#### **Airworthiness Directives; Eurocopter France Model AS350B, BA, B1, B2, B3, C, D, and D1; EC–130B4; and AS355E, F, F1, F2, and N Helicopters**

**ACTION:** Notice of proposed rulemaking (NPRM).

**Eurocopter France:** Docket No. FAA-2007-27495; Directorate Identifier 2005-SW-14-AD.

Figure 1

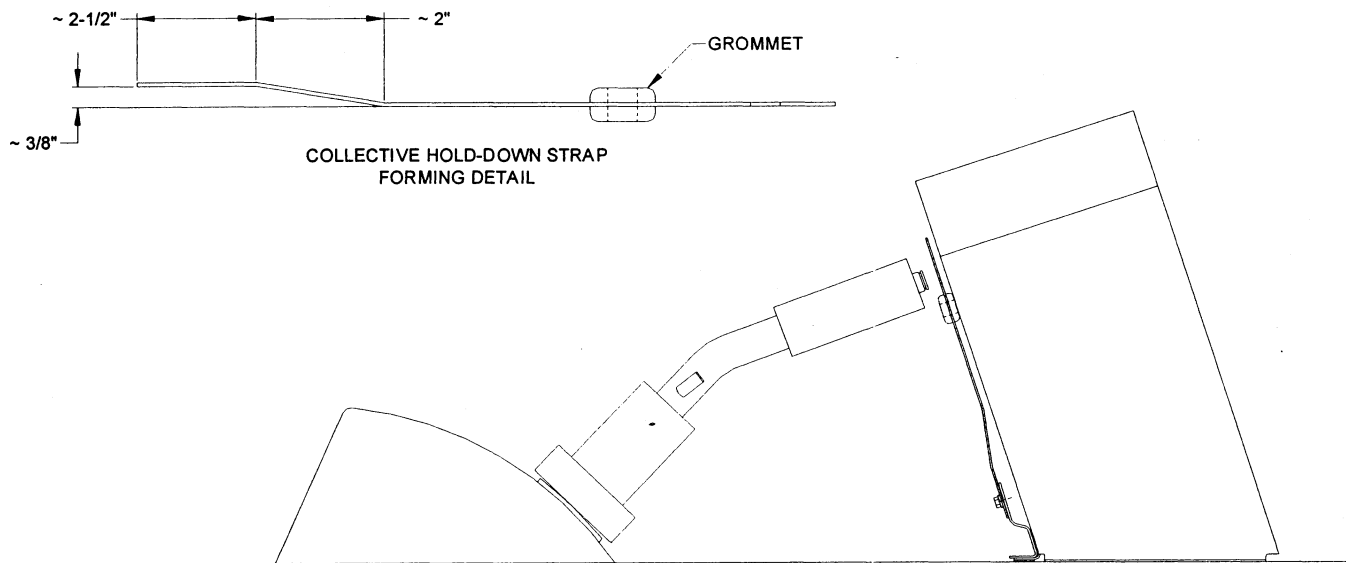
- (a) Within the next 30 days, unless accomplished previously, modify the strap by forming the strap as depicted in Figure 1 of this AD. Install the modified strap so that the rubber grommet rests against the console. Thereafter, at intervals not to exceed 100 hours time-in-service, inspect the strap to ensure that the rubber grommet is resting against the console.

To ensure that the strap does not inadvertently lock the collective during normal operation, the strap must be formed by joggling it as shown in the figure. When formed correctly, the strap will naturally touch the console aft wall, requiring it to be flexed in order to lock the collective.
